**Corrigendum:** Empowering Ukraine Through a Decentralised Electricity System

**Issued:** February 2025

**On page. 46, the figure below:**

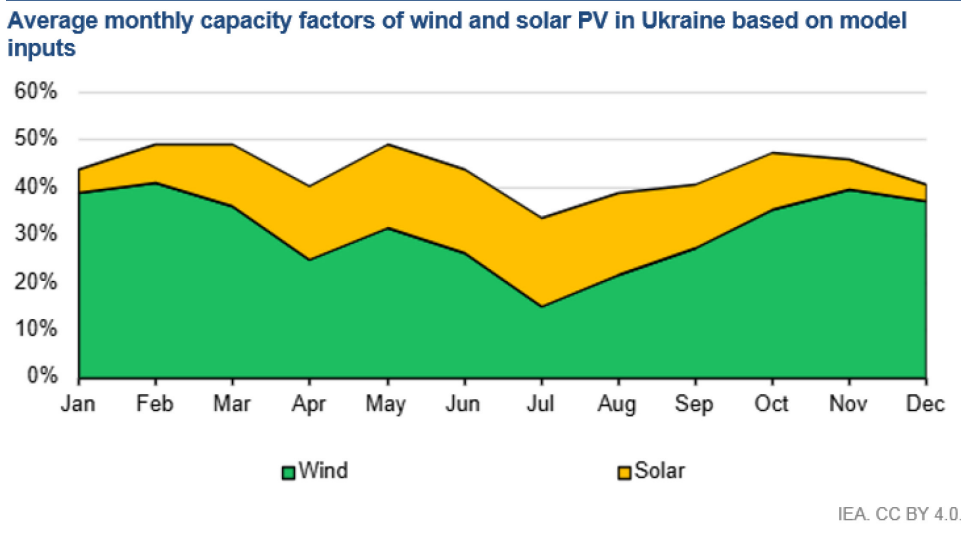
**Was replaced with updated figure**
